FULLER-TURNER-WALSH-SLATTERY, INC.
UNITED NATIONS CONTRACT
NEW YORK

Dear Mr. Dawson: **Re: Contract HQ 1/74 - Parking Space, SH**
 Approved Shop Drawings

Re: Contract HQ 1/74
Parking Space - South Half
Acoustical Materials

Re: Contract HQ 1/74 - Parking Space-SH
Miscellaneous Iron Shop Drawings

3 No. 15 16 June '50 Alteration to Duct in I.R.T. Shaft
(APPROVED 11 Oct. 1950 R.E.N.)

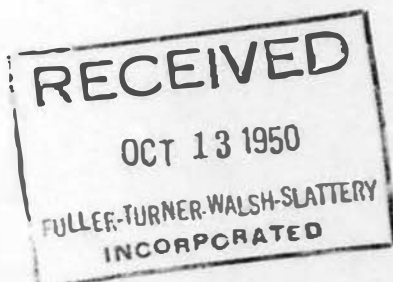
"This drawing is approved, subject to verification of all structural conditions and sizes at building, as stated in the Specifications, Section 8-11."

"All approvals are subject to strict compliance with the Contract Plans and Specifications and to all Authorities having Jurisdiction."
